SUBJECT: ST. LUCIE PLANT, UNIT NO. 2 – RELIEF REQUEST NUMBER 6,
REVISION 0 – ALTERNATIVE FOR EXAMINATION REQUIREMENTS OF
SNUBBERS (TAC NO. MF4336)

SAFETY EVALUATION BY THE OFFICE OF NUCLEAR REACTOR REGULATION

RELIEF REQUEST NO. 6, REVISION 0,

ST. LUCIE PLANT, UNIT NO. 2

Figure 1

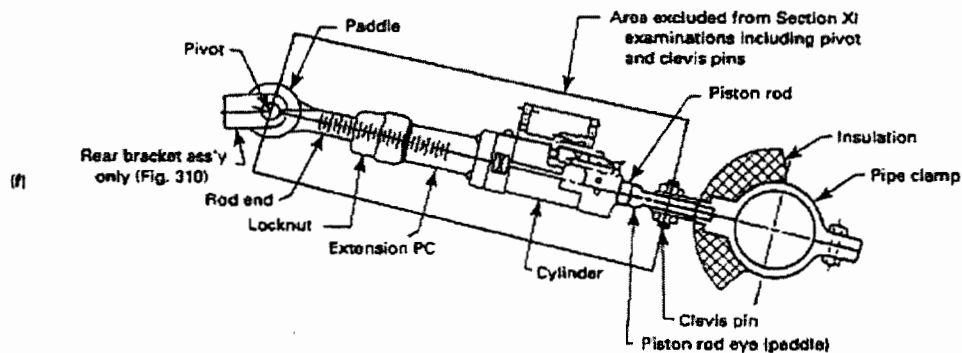
The 2007 Edition through the 2008 Addenda of ASME Section XI contains Figure IWF-1300-1(f), which depicts the examination boundaries for snubber (as shown in Figure 1 below).

The boundaries indicate that the attachment of the snubber to the pressure boundary and building structure is required to be examined in accordance with IWF-2000, whereas excluded snubber (pin-to-pin) to be examined per ASME OM Code.

The licensee states that in order to eliminate the duplicate of effort by tracking two different examination boundaries for one component, SL-2 requests alternative, proposes to perform the visual examination of snubbers and associated attachment hardware (pin-to-pipe and pin-to-structure, excluding integral attachments) per the Snubber Program in lieu of the requirements specified in IWF-2500 of ASME BPV Code, Section XI.

- (1) The ASME Section XI, 2007 Edition including the 2008 Addenda, Figure IWF-1300-1(f) specifies boundaries between snubber and its attachments, because snubber (pin-to-pin) examination and testing are moved in to the ASME OM Code. RR No. 6, Revision 0, proposes to perform the visual examination of snubbers and associated attachment hardware (pin-to-pipe and pin-to-structure, excluding integral attachments) along with snubber (pin-to-pin) visual examination in the Snubber Program.

The NRC staff reviewed all the information provided in SL-2 submittal and response to RAIs, and found that the proposed examination boundaries of snubber and associated attachment hardware (pin-to-pipe and pin-to-structure, excluding integral attachments), per the Snubber Program, are acceptable, based on the following:

Based on above, the NRC staff finds that the licensee proposed alternative of snubber boundaries for visual examination, which includes snubbers and their attachments, provides an acceptable level of quality and safety.
